CITY OF ALBUQUERQUE

May 5, 2015

**RE: Volcano Cliffs Subdivision Lot 3 Block 8 Unit 22
6420 Canavio Pl NW
Grading and Drainage Plan
Engineers Stamp Date 4/15/15 (D10D003E3)**

GRADING AND DRAINAGE PLAN
LOT 3 , BLOCK 8 , UNIT 22 , VCS
ADDRESS: 6420 Canavio Pl NW

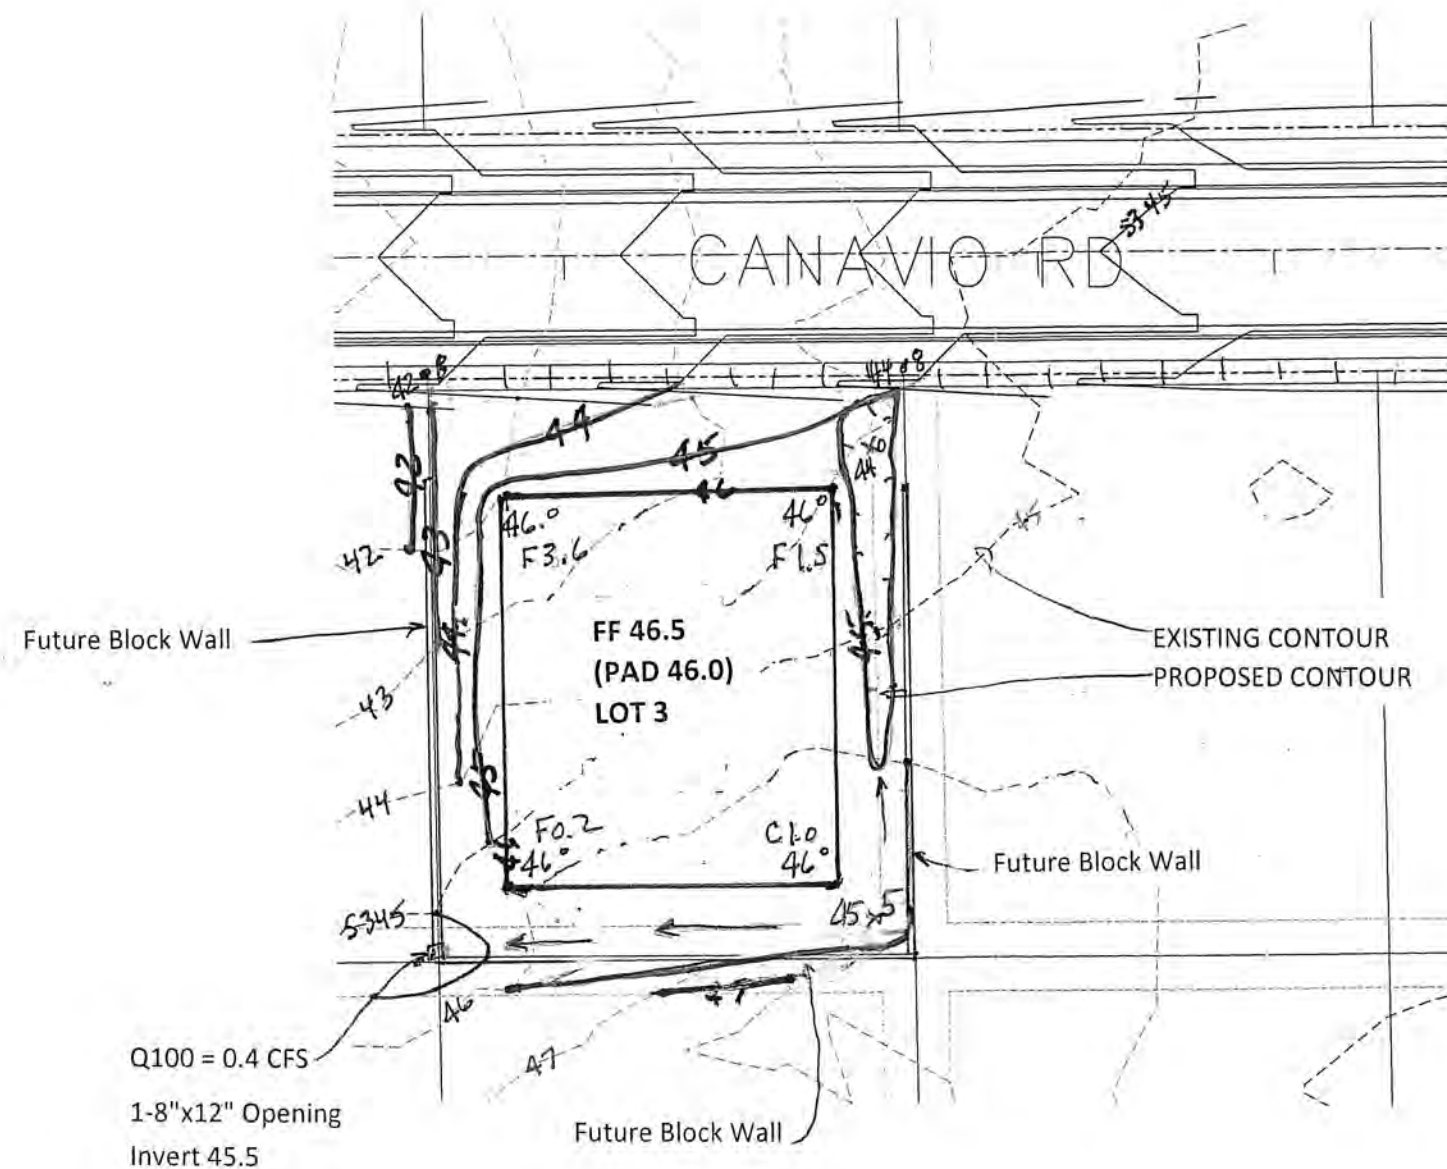
Based upon the information provided in your submittal received 4/15/15, this plan is approved for Grading Permit and Building Permit.

Please attach a copy of this approved plan to the construction sets in the permitting process prior to sign-off by Hydrology.

Prior to Certificate of Occupancy release, Engineer Certification per the DPM checklist will be required.
